UN Regulation No. 26 (External projections of passenger cars)

Proposal for Supplement 4 to the 03 series of amendments to UN Regulation No. 26 (External projections for passenger cars)

Submitted by the expert from France*

Figure 0

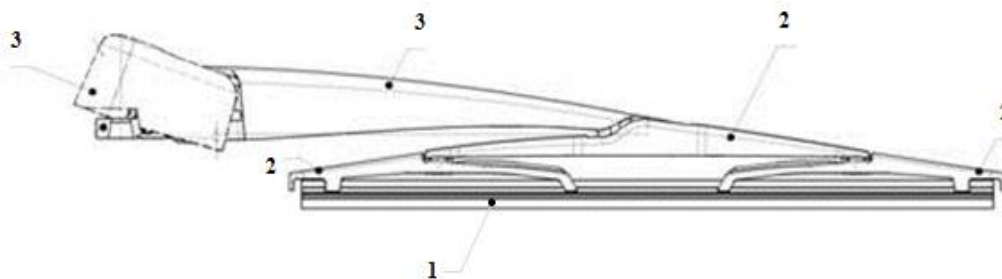
6.4.1. The windscreen wiper fittings shall be such that the wiper shaft (**numbers 3 in Figure 0 below**) is furnished with a protective casing which has a radius of curvature meeting the requirements of paragraph 5.4. above and an end surface area of not less than 150 mm². In the case of rounded covers, these shall have a minimum projected area of 150 mm² when measured not more than 6.5 mm from the point projecting furthest. These requirements shall also be met by rear window wipers and headlamp wipers.

6.4.2. Paragraph 5.4. shall not apply to the wiper blades (**number 1 in Figure 0 below**) or to any supporting members (**numbers 2 in Figure 0 below**). However, these units shall be so made as to have no sharp angles or pointed or cutting parts.

In order to avoid any misunderstanding on requirement applied to parts of the windscreen wiper, a simple generic drawing presenting the concerned areas seems to be the best way for an appropriate application of the provisions.
